MFN 15-053

GEH Responses to RAIs 19-6 through 19-9

ABWR DCD DRAFT Revision 6 Markups

FIGURE 3H.1-23 REACTOR BUILDING REACTOR CAVITY SHIELD BLOCKS
 ABWR DCD REV 6 25A5675BB

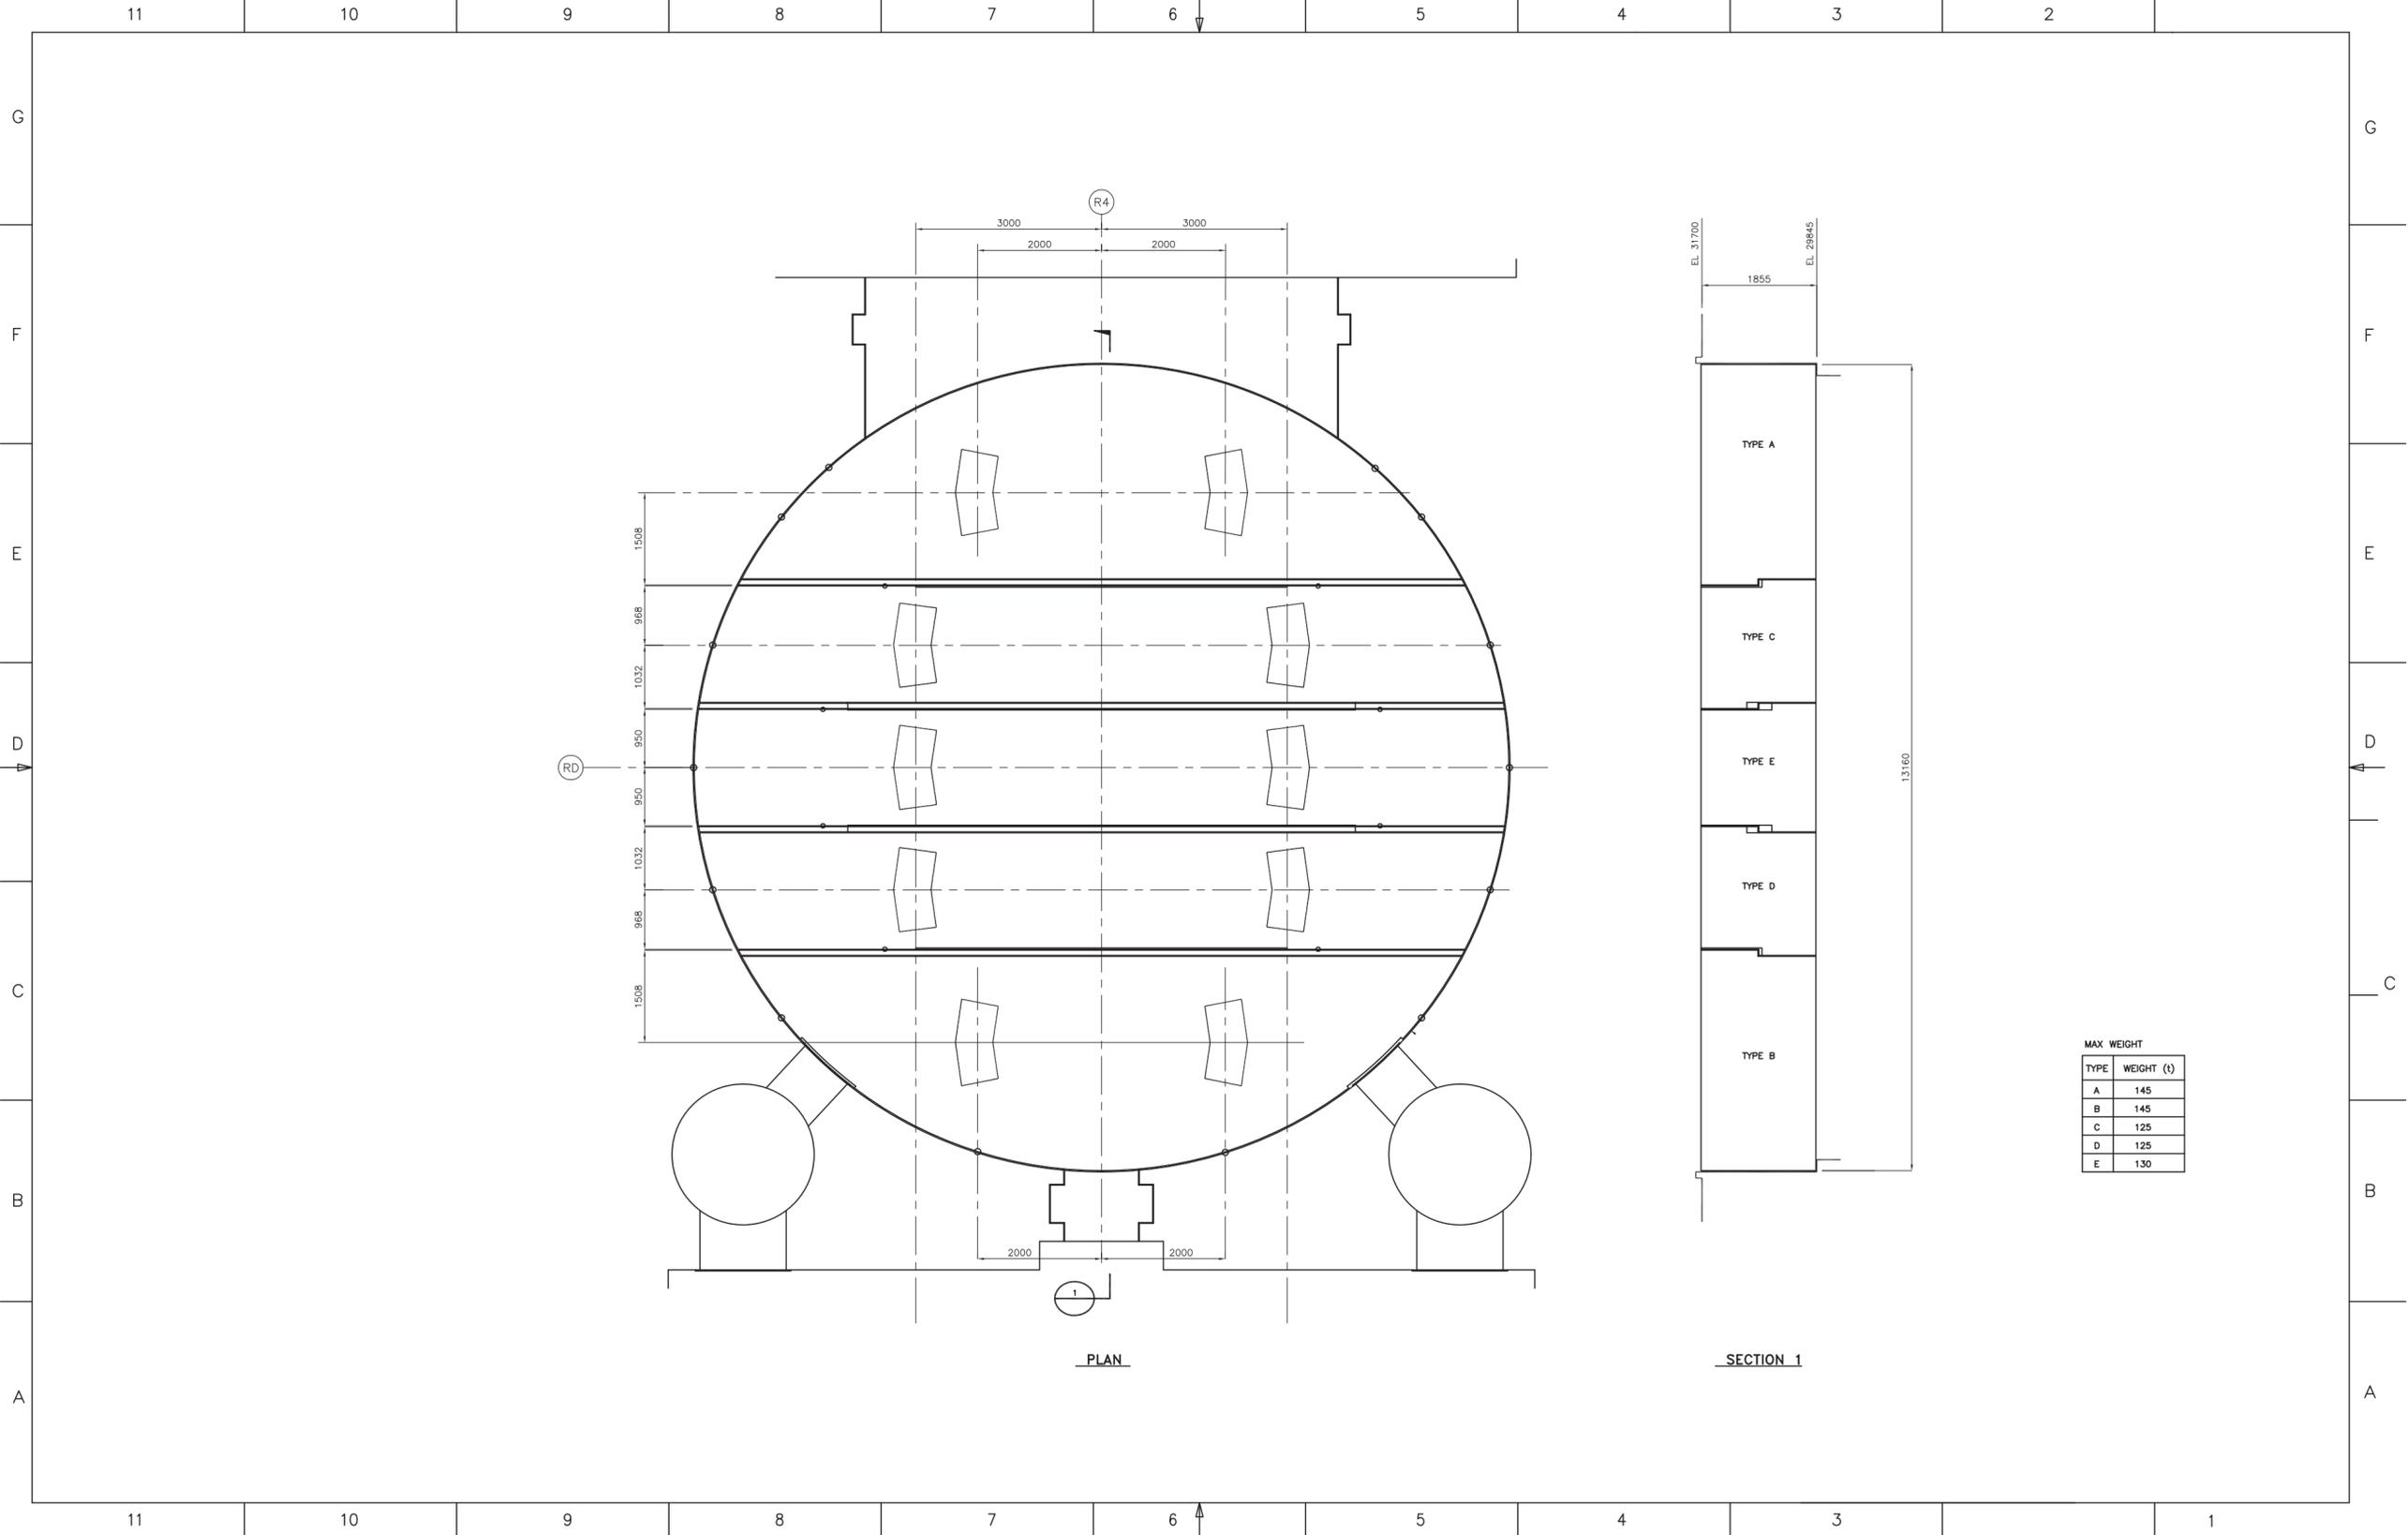
Reactor Cavity Shield Blocks as shown in Figure 3H.1-23 sit above the drywell head in the reactor cavity between the fuel pool girders. They provide missile shielding for the drywell head, and radiation shielding for maintenance personal on the operating floor during normal plant operations.

- (3) Shield blocks over drywell head ~~to be~~ **are** designed to fully resist secondary impact from concrete debris, aircraft wreckage, and falling crane components to protect integrity of drywell head.

The reactor cavity shield blocks are shown in Figure 3H.1-23.

12 and external barriers as shown in Figures 1.2-8 and 1.2-9 that, in combination with the external wall, protects the critical penetrations. That analysis was also used to determine the key design features for the ~~reactor well shield plugs~~ reactor cavity shield blocks for protecting the drywell head from secondary impacts as identified in Section 3H.1.4.
